# Access Compliance Report

## Public Rights-of-Way

### (Curb Ramps)

Intersection ID: 11171	Main Street: ARIA_CT	Cross Street: AVENTIDE_LN	Location:	SE
ADA ID: 9EEE7FEB0F00	Ramp Type: BlendTrans1	Initial Pass/Fail: Fail	Overall Compliance: No	Severity Score: 10
Codes/Mitigation Info/Possible Solution		Field Measurements/Component Compliance

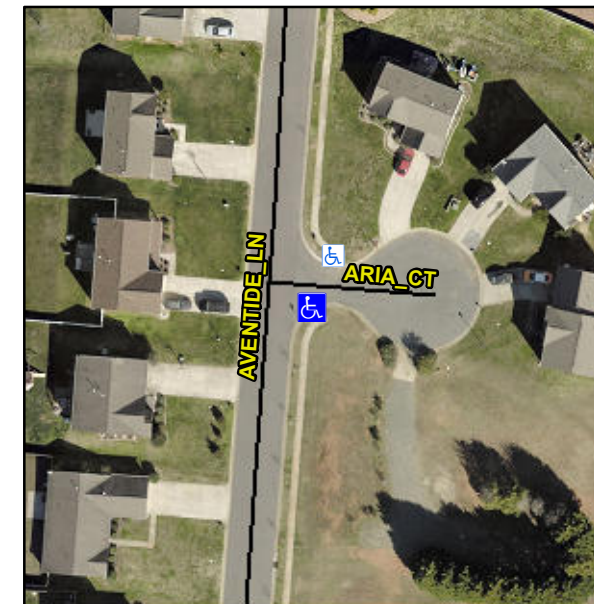
**NO LT SW**

**Not Found, R304.5.1, R304.5.3**

**Remove & Replace Curb Ramp With Two New Directional Ramps or Equivalent.**
